***Conceptual Design Study
Report for TSF-26
PM-2A Tanks for Test Area
North Operable Unit 1-10***

INEEL/EXT-02-01412

**U.S. Environmental Protection Agency Comment
Resolutions on Design Study**

Figure 3. Summary-level logic diagram for the modified (new) remediation plan for the Test Area North PM-2A tanks.

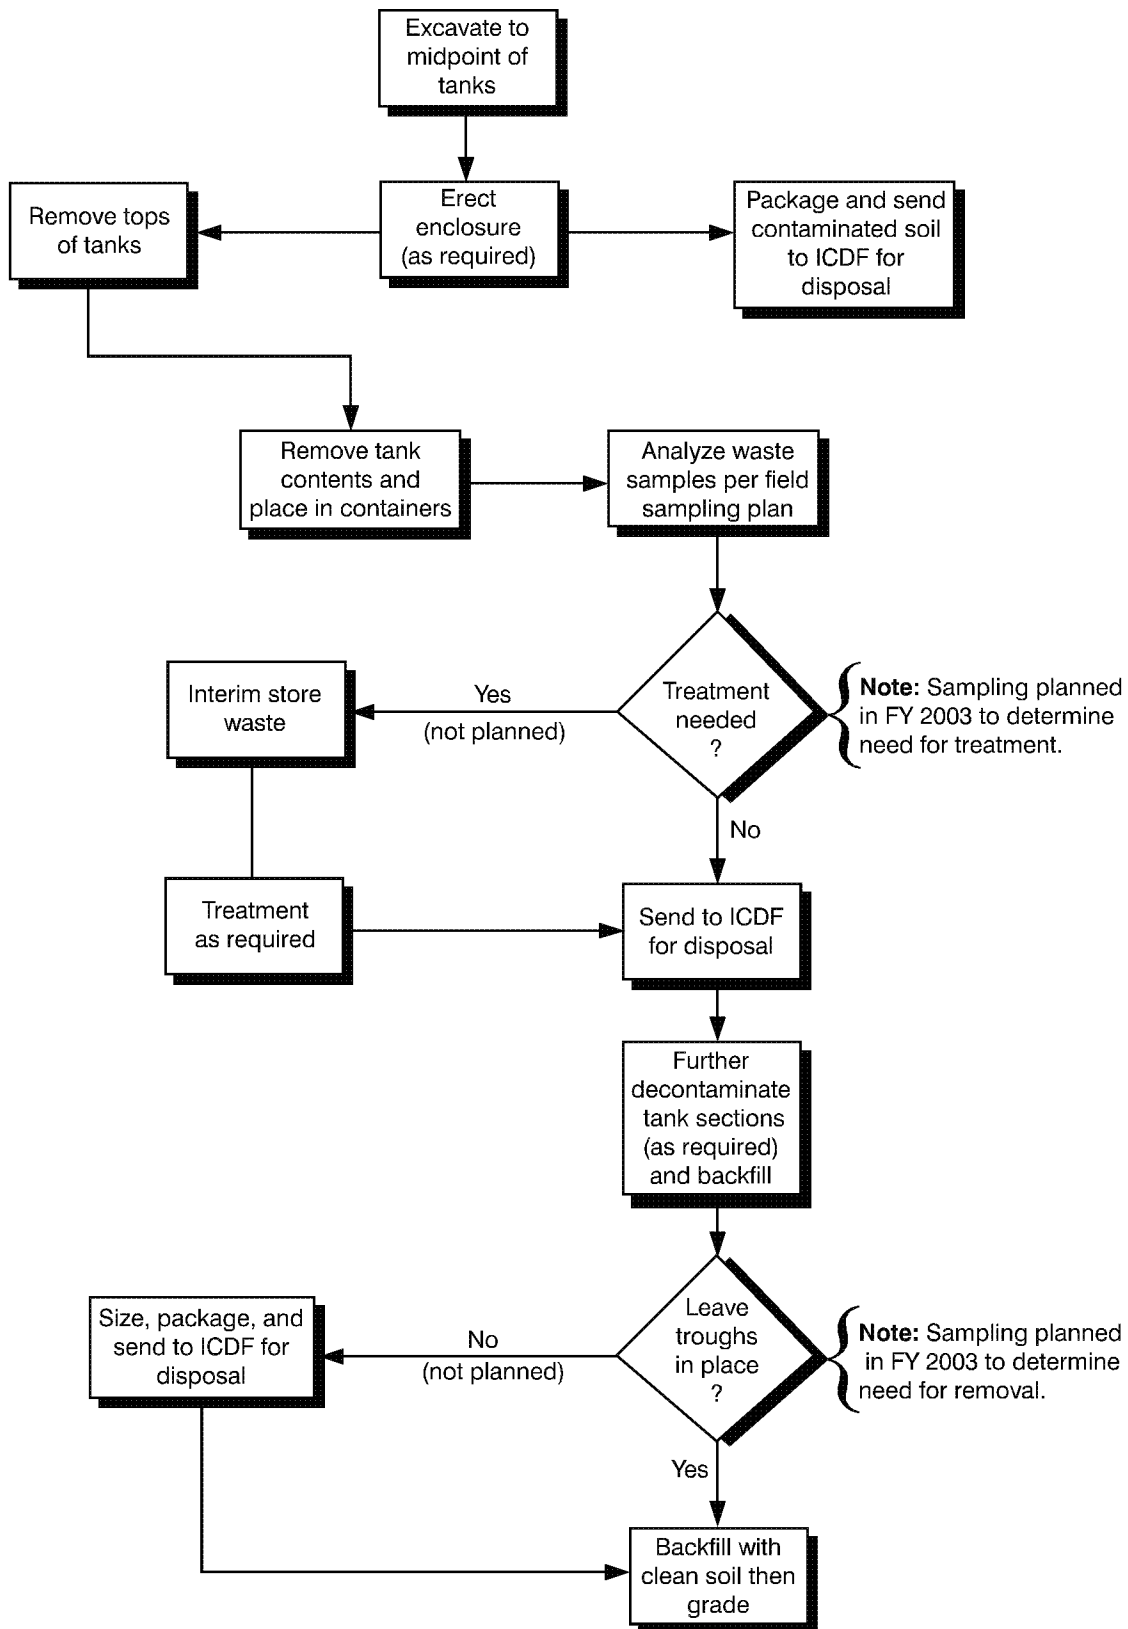
ITEM NUMBER	SECTION NUMBER	PAGE NUMBER	COMMENT	RESOLUTION
3	Figure 3	10	EPA recommends adding a decision point between the "Send to ICDF for disposal" box and the "Decontaminate tank sections and back fill" box. Testing should be performed to determine if decontamination is necessary. Section 3.7 indicates that the new approach should be adequate to decontaminate the tanks.	Comment incorporated. However, rather than add an additional decision point, the "decon" box was modified as follows: "Further decontaminate tank sections (as required) and backfill."
